Myuna Colliery Extension of Mining Project Response to Submissions

November 2011

Figure 1 – Revised Seagrass Habitat and SMZ Plan to Include Pulbah Island

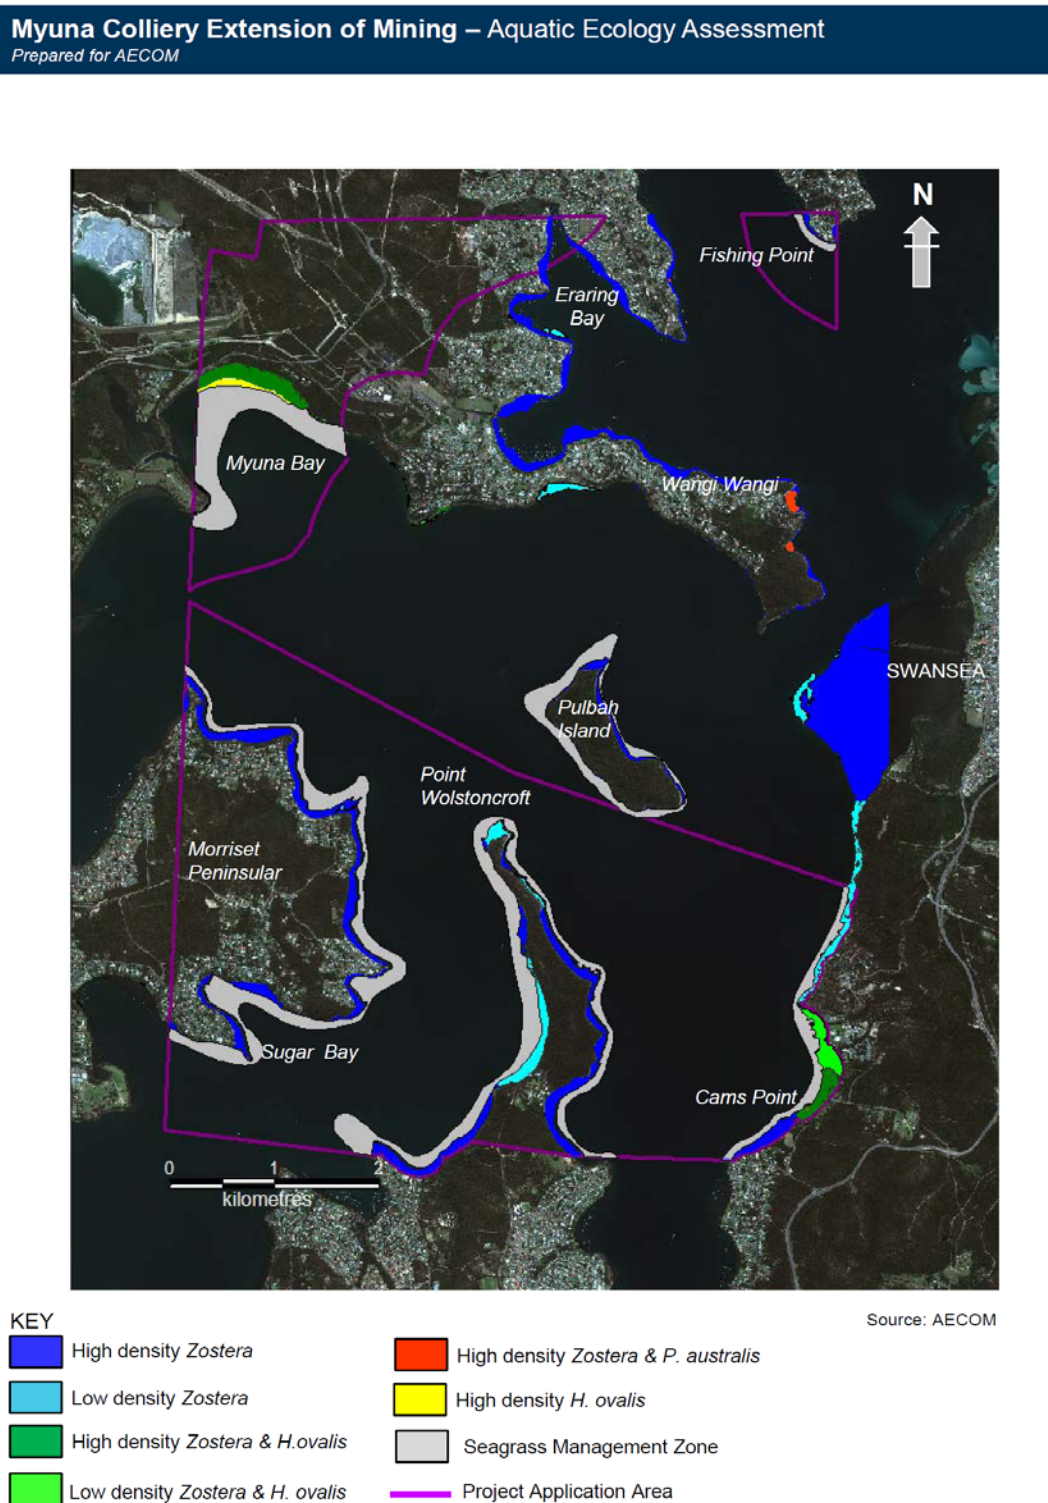
The Environmental Assessment fails to address all water depths where seagrass may grow. Zone A should not just include current seagrass distribution, but should include all water depths where seagrass may grow. This is identified in the ecologists report as water depths up to 5 metres.

A seagrass assessment should be undertaken prior to any additional underground mining activities within Zone A and a management strategy developed for monitoring and remedial action to prevent impacts on seagrasses from the proposal.

In addition to establishing a SMZ within the Project Application Area, Centennial Myuna has identified the area and extent of seagrass habitat around the Pulbah Island State Conservation Area located within the existing Development Consent Area for the Myuna Colliery. To ensure the protection of seagrass habitat around Pulbah Island, Centennial Myuna have will establish a SMZ around Pulbah Island as well. The SMZ around Pulbah Island will have the same levels of controls applied to it as identified above and described in detail within the Environmental Assessment. A revised figure 7 from the Myuna Colliery Extension of Mining Project Aquatic Ecology Assessment has been included in this Response to Submission which details the location of seagrass beds and the associated SMZ around Pulbah Island.

An Aquatic Ecology Assessment was undertaken by Cardno Ecology Lab for the proposed Project and is discussed in section 10.4 and provided in Appendix I of the Environmental Assessment. Field investigations carried out as part of the Aquatic Ecology Assessment and previous habitat mapping carried out within Lake Macquarie (Creese et al. 2009) shows seagrass beds fringing the majority of the foreshore within the survey area and Project Application Area
